MOONEY AIRCRAFT INC.
KERRVILLE, TEXAS

SERVICE LETTER 20-4
SERVICE BULLETIN M 20-4

SUBJECT: Carburetor Float Height

MODELS AFFECTED: M-20 Serial Nos. 1002 thru 1008, 1010 thru 1026

Figure 1.

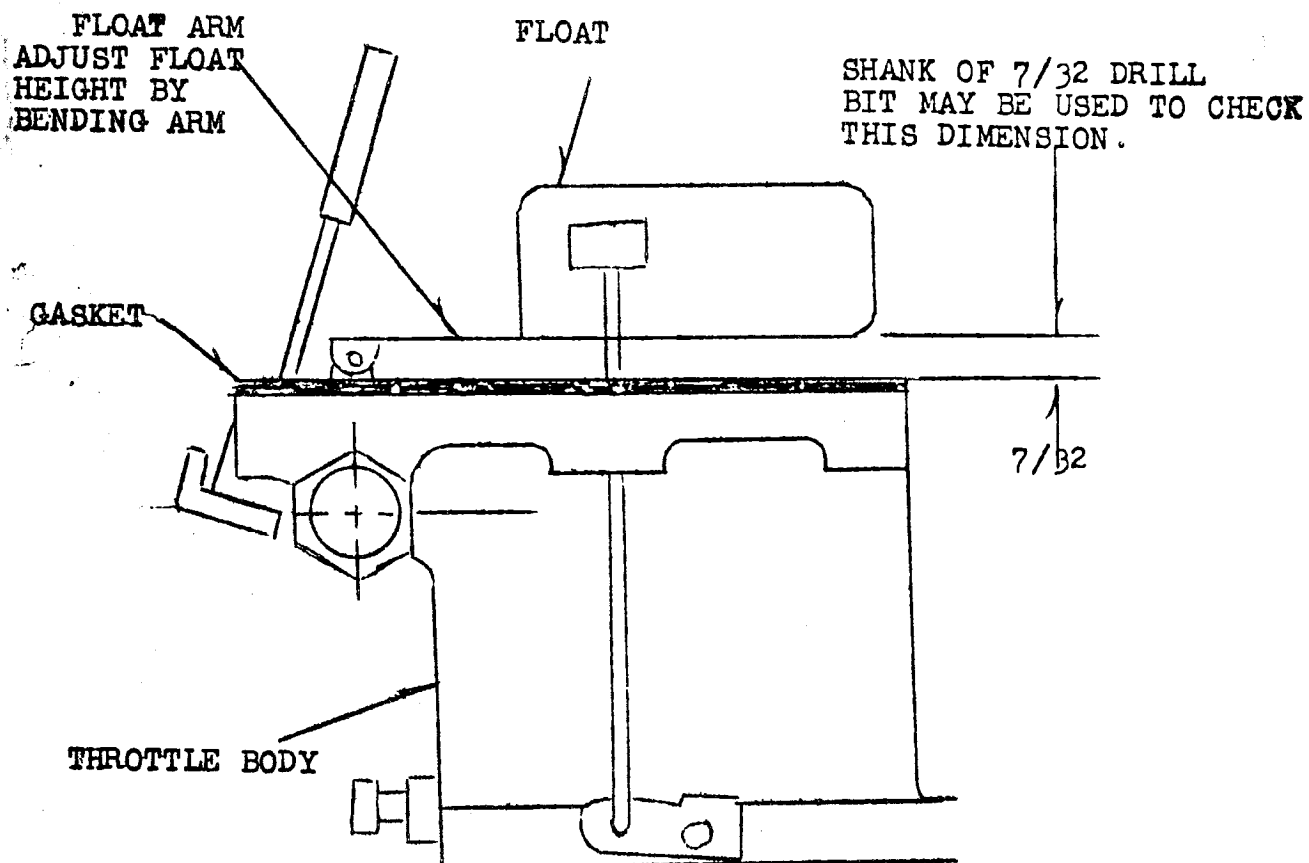
Upon examination of a number of carburetors it was found that the float height was incorrect. This situation causes engine roughness. All carburetors are now being inspected by Mooney Aircraft for proper float height before installation.

1. Having removed the carburetor from the engine detach the throttle body from the bowl assembly.
2. Inspect and set the float height if necessary as shown in figure 1.
